STATE OF WASHINGTON
DEPARTMENT OF ECOLOGY

Re: Port Angeles Rayonier Mill Site - Coastal Conceptual Site Model and Hydrodynamic Modeling Action Plan (August 2, 2024) and Draft Pre-Remedial Design Work Plan Under-Dock and Nearshore Areas (August 30, 2024)

MEMORANDUM

Subject: RAMP August 2024 Modeling Memo Review and Comments

Figure 1: Ennis Creek. USDA NAIP 8/21/2017

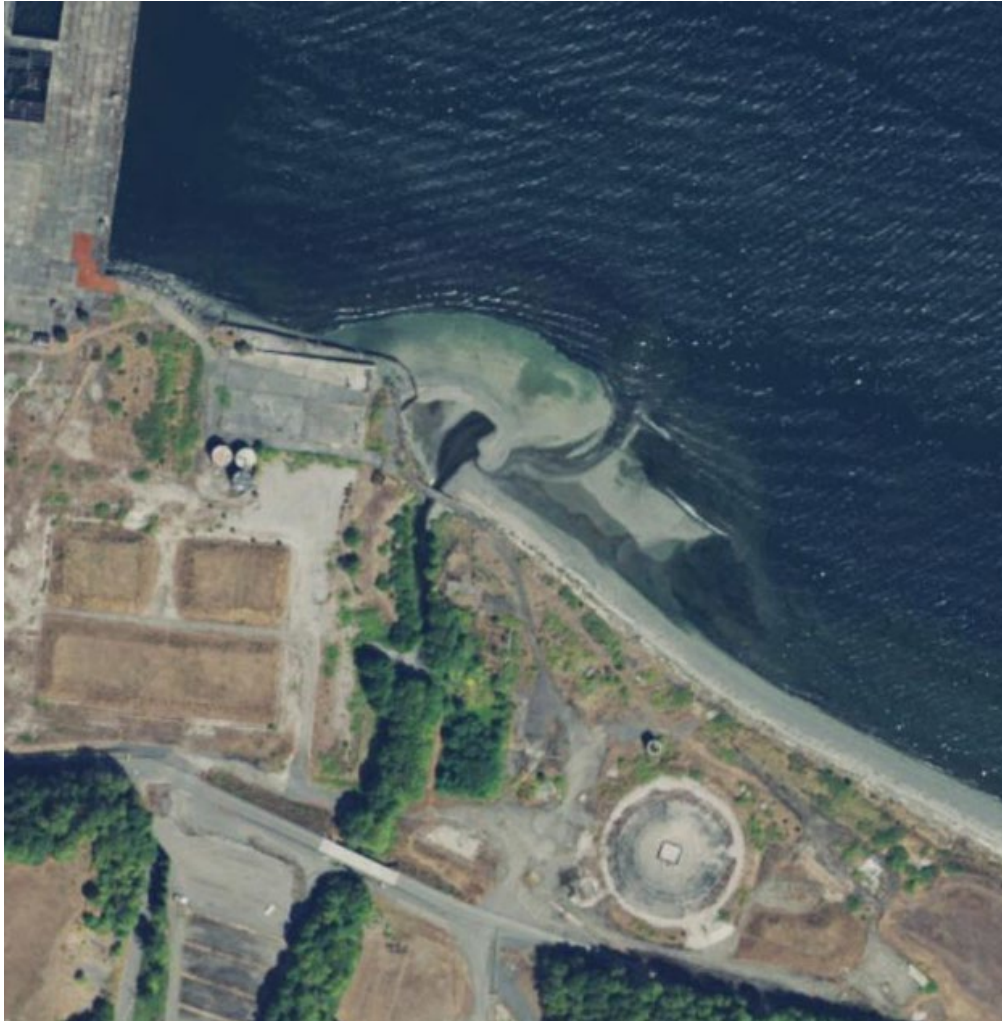
- Ennis Creek was noted as a potential sediment source for the shoreline to the west of the creek mouth, and potential restoration of its estuary was noted as an obstacle to developing a CSM or restored site in Modeling Memo Sections 3.4 and 4.2. While it is inappropriate for the Modeling Memo to have commented on negotiations involving third parties, development of a comprehensive CSM can best assess the importance of the Creek's sediment input on the decision framework process. If necessary, the remedy should address that contingency.

- Modeling Memo Section 3.4 mentions impacts to fish habitat due to barriers. Culverts at E. Ennis Creek Road and US 101 are scheduled for removal.
- The 2005 Elwha-Dungeness Watershed Plan states that landslides appear to be the dominant source of sediment into the creek.

Figure 4: CSM (Contour shifts relative to geomorphic changes responding to shoreline modification). Note the impact on the -15' contour and areas deeper within the pier and jetty areas.

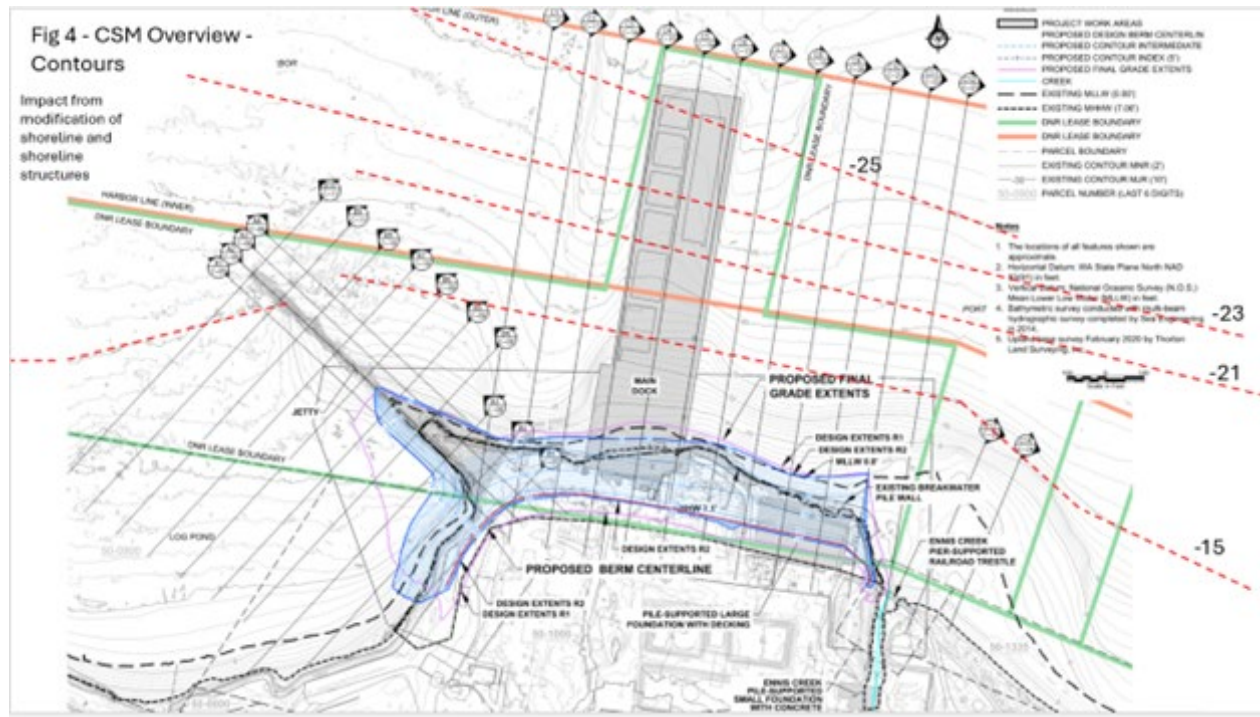
- CSM should address historical changes observed at the site through the various modifications as an element of calibrating the analysis leading to conclusions. This would include connecting the coastal processes (waves, currents, sediment transport) to the observed changes from shoreline modifications (pier, jetty, dredged berths, beach nourishment programs, etc.). See Figure 4.
